**Letter of Objection to the development at Former Tower
Car Sales, Tower Close, East Grinstead, West Sussex (now known as
Whittaker House, 1 Leppard Walk) and
retrospective application DM/26/0432**

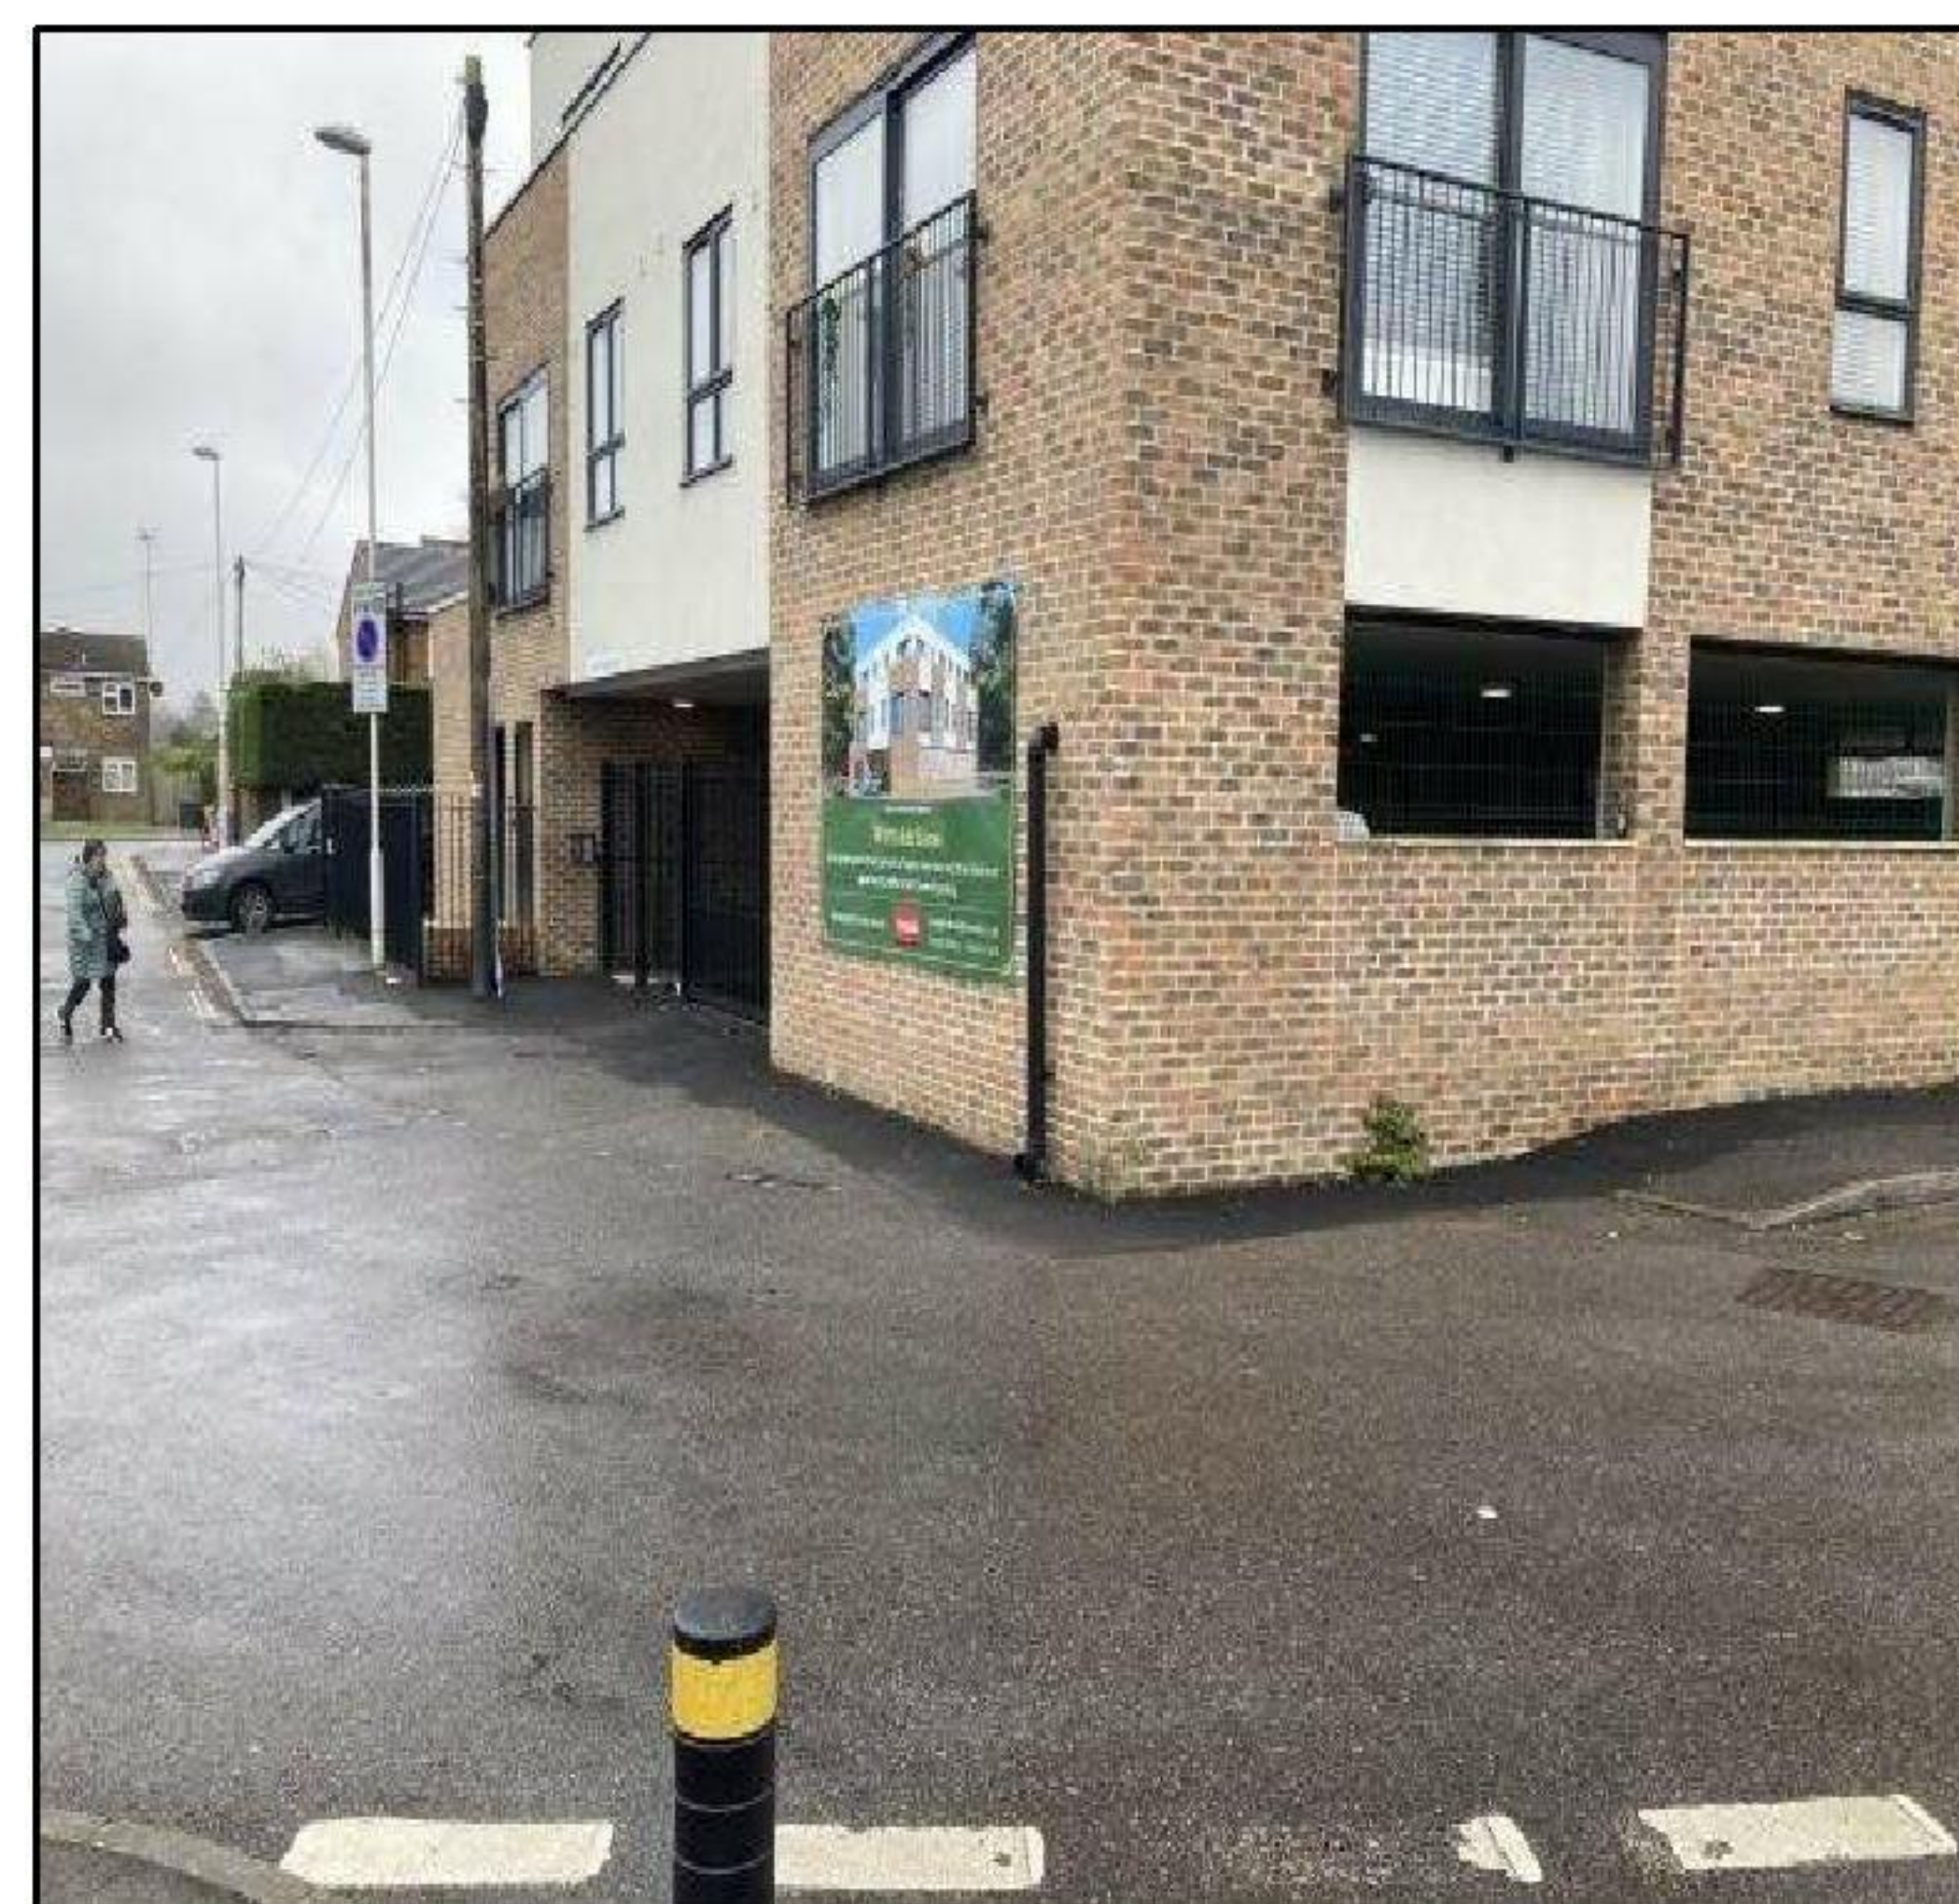
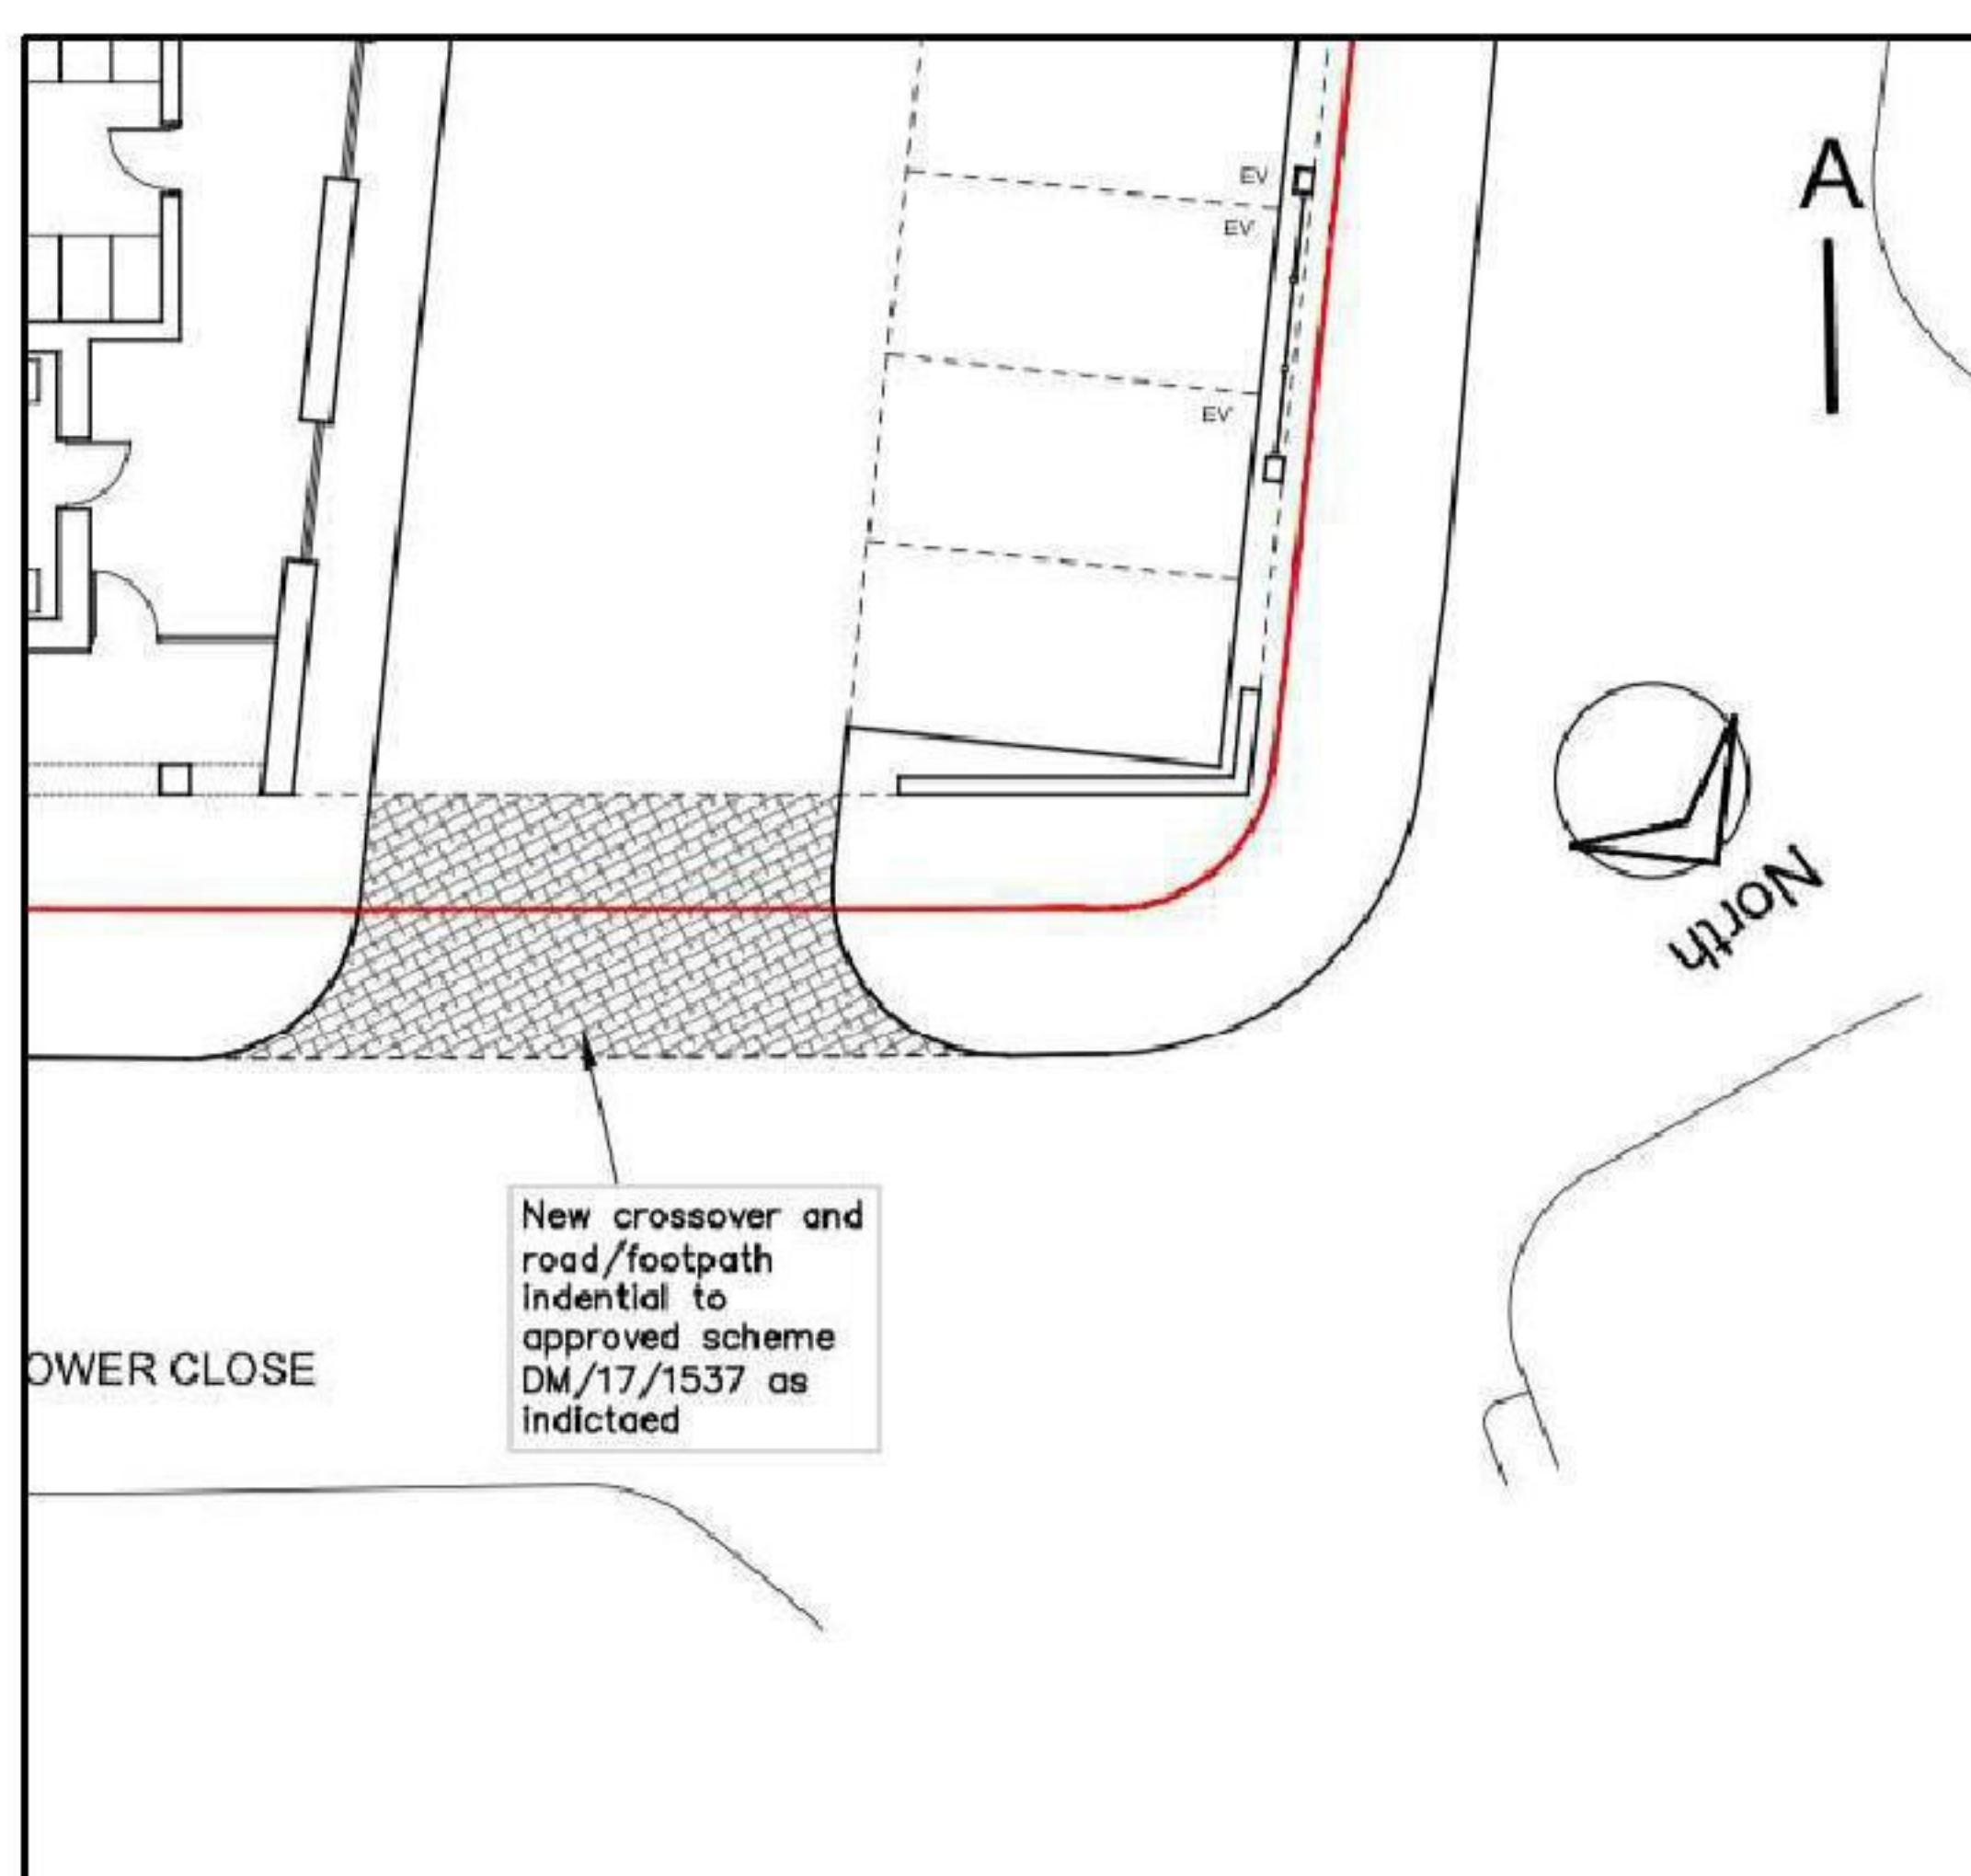
The developer has already placed an unauthorised 9th space, and you can clearly see he has installed EV charging points for 10. It's obvious that a 10-space layout was always the plan, with no intention whatsoever of building to the approved scheme. A 10th space would completely obstruct the parking for Flats 2, 3 and 4, but, as with everything else, you can see the developer has been trying to force 10 cars into this car park from the very beginning.:

The development has also always had a low brick wall cutting off the walkway seen in the approved plan, I suspect to keep as much width for the unauthorised extra spaces as possible.

Unsurprisingly, this wall does not appear on any of the plans submitted in support of the proposed additional parking space, and combined with the bins, takes up a large area of the undercroft (9 food waste caddies awaited). This further highlighting the gap between what was approved and what was actually built:
